LAUGHLIN INDUSTRIAL PARK SUBDIVISION, **RESUBDIVISION OF LOTS 9-11**

APPLICATION NUMBER 14 DATE June 16, 2011

REQUEST Subdivision

DETAIL SITE PLAN

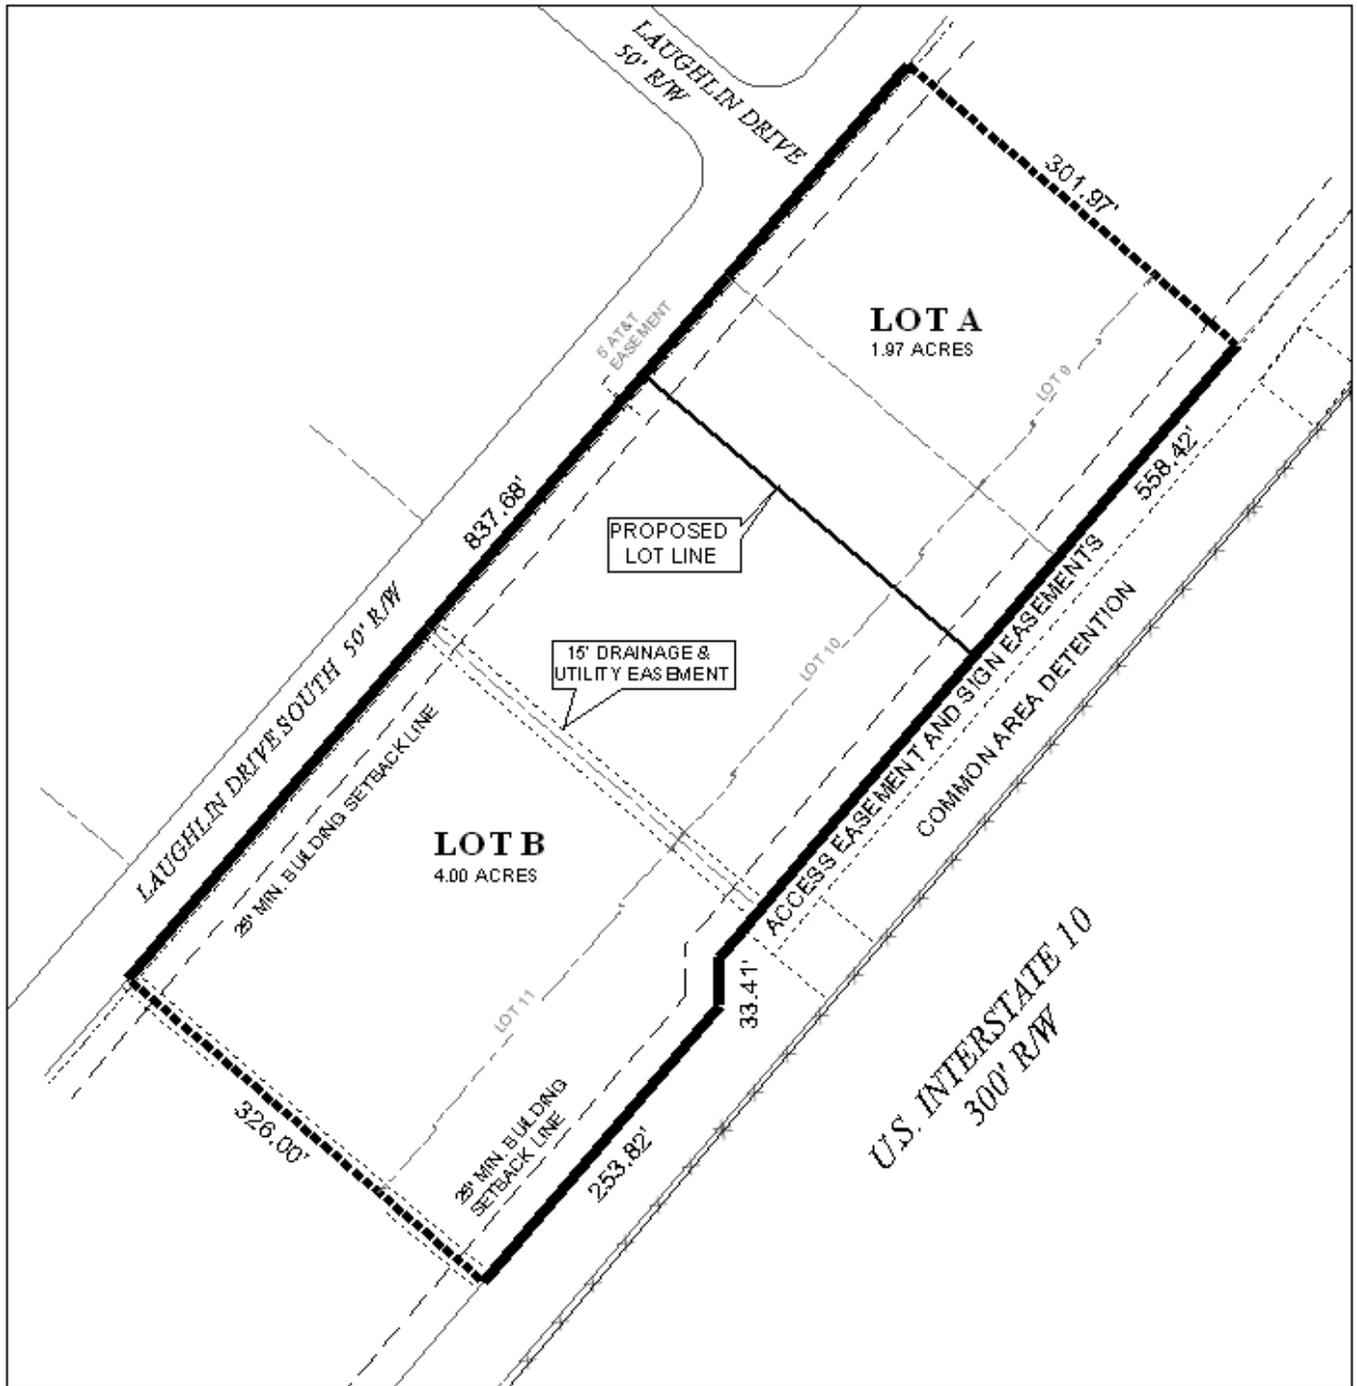
The proposed lots, as depicted, meet the minimum size and frontage requirements as regulated by the Subdivision Regulations. The lot area sizes and 25-foot minimum building setback line are depicted on the plat in square feet, and this should be retained on the Final Plat, if approved.

The lots front Laughlin Drive South to the North and Interstate 10 to the South. Laughlin Drive South is a minor street provided with curb and gutter, and the plat depicts it with an adequate 50-foot right-of-way. No further dedication should be required. Should the application be approved, Lot A should be limited to one curb cut and Lot B should be limited to two curb cuts, with the size, design, and exact location of all curb cuts to be approved by Traffic Engineering and conform to AASHTO standards.

- 1) retention of minimum building setback line and lot area sizes, in square feet, on the Final Plat;
- 2) placement of a note on the Final Plat stating that Lot A is limited to one curb cut and Lot B is limited to two curb cuts, with the size, design, and exact location of all curb cuts to be approved by Traffic Engineering and conform to AASHTO standards; and
- 3) placement of a note on the Final Plat stating that development of the site must be undertaken in compliance with all local, state and Federal regulations regarding endangered, threatened or otherwise protected species.
